Modification ⊠	Recurring action	One-off action □
	No	o. 292 72 2057
ARRIEL 2 B - B1 - C - C-F	PM - C1 - S1	
power turbine/r	reduction gearbox). Improreduction gearbox coupling modification TU 57.	
Date on which this SB becomes conditions of application.	effective and must systematically be	complied with, according to the
conditions of application.	effective and must systematically be	
conditions of application.  This is the date all resources (available.

**Version**: C

Merger of SB No. 292 72 2057 and SB No. 292 72 2057M.

**ANNEXE 1** / APPENDIX 1

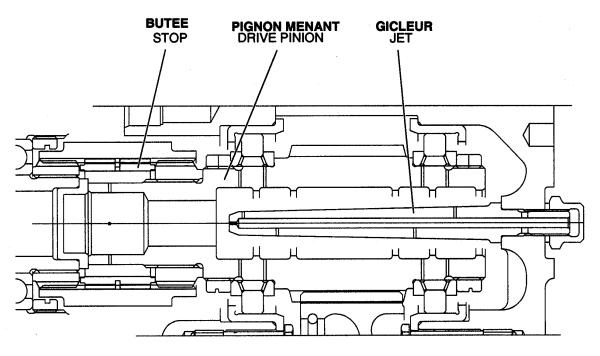
- ensuring additional lubrication in the front cavity of drive pinion with:
  - the addition of jets and a shoulder to separate the flow to the drive pinion,
  - the extension of the jet body to position the extremity facing the sleeve.
- improving distribution of the oil flow to the splines and reducing the rotating mass of the sleeve by:
  - reducing the sleeve diameter,
  - adding a shoulder to separate the flow.
